CITY OF ALBUQUERQUE, PLANNING DEPARTMENT

PRE-APPLICATION REVIEW TEAM (PRT) DISCUSSION

PA # 13-038 RECEIVED BY ERIN G DATE 3-22-13
APPLICANT Dave Starr TEL # 891-9444 Email starrernch@aol.com
APPOINTMENT DATE & TIME March 26, 2013 3:00 P.M.

B11D008
CoA Drainage #

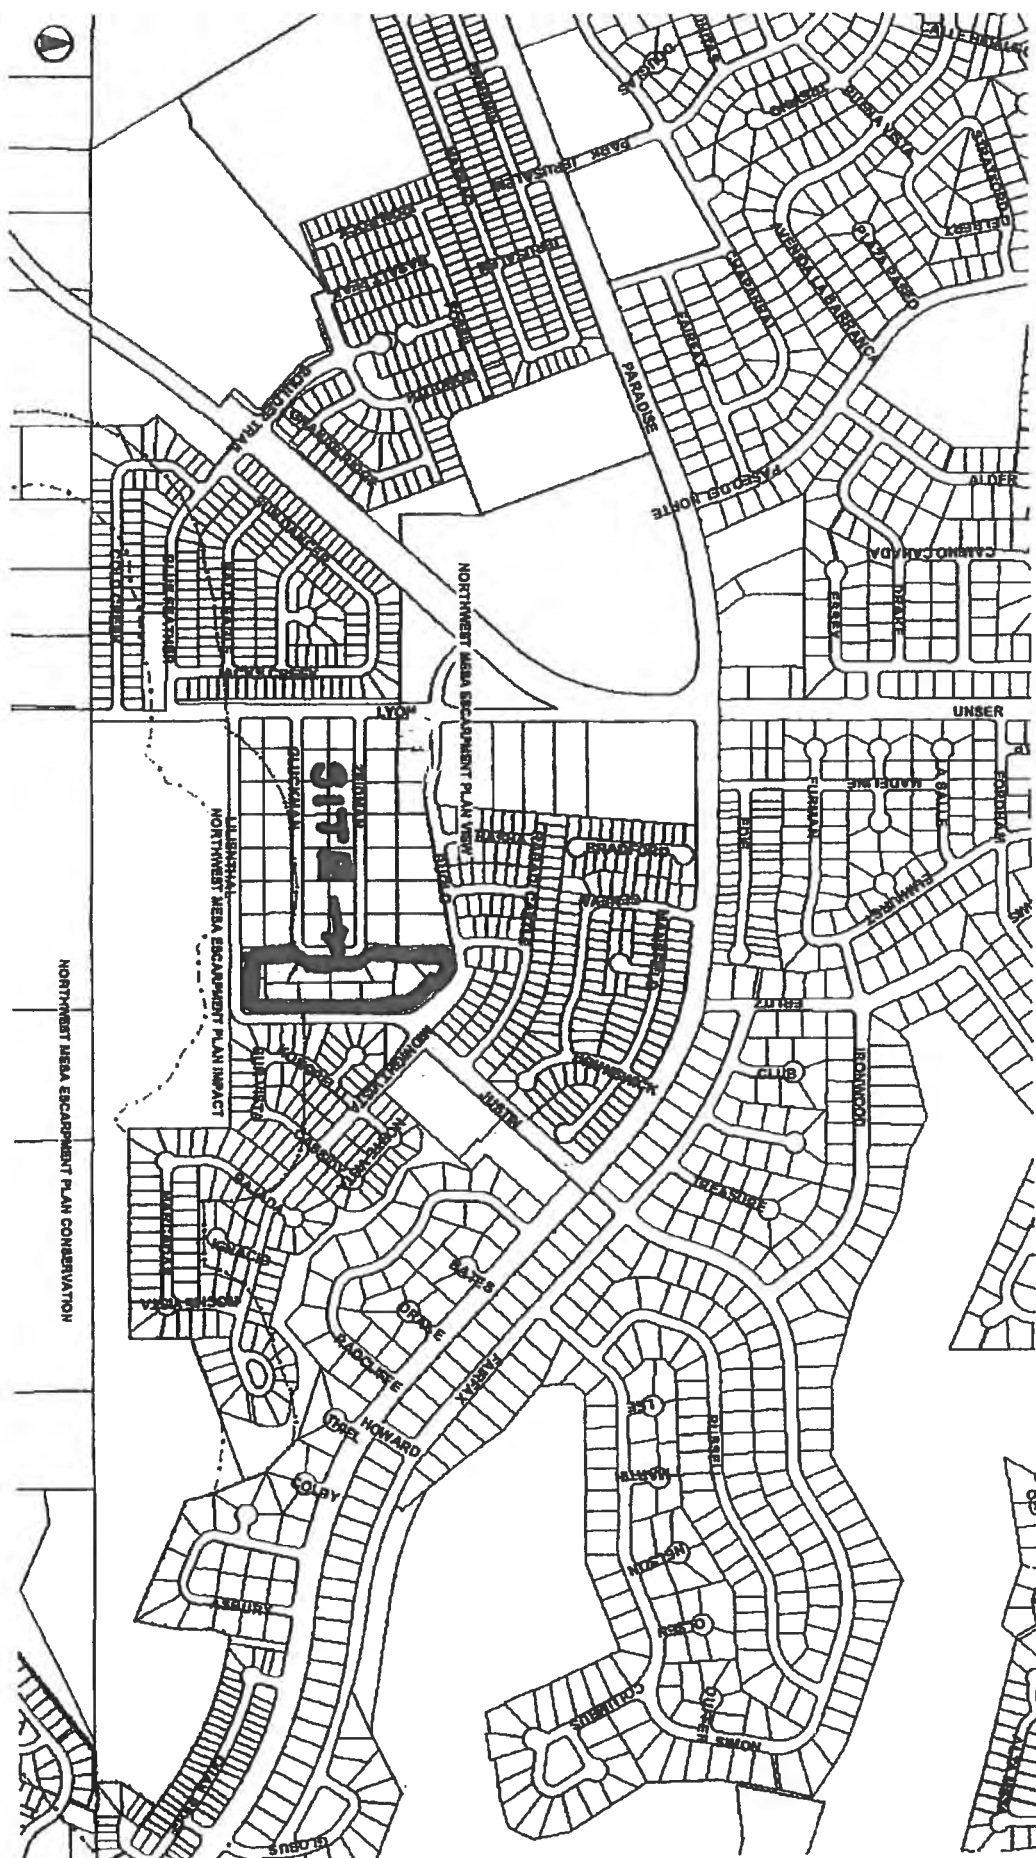
Possibly Vacant Rd

Look @ the off-site land
to accept the off-site plans

Possible Pond

Location
Discharge
Detail & Approved

With Review
Approved
Spreadsheets
for Discharge
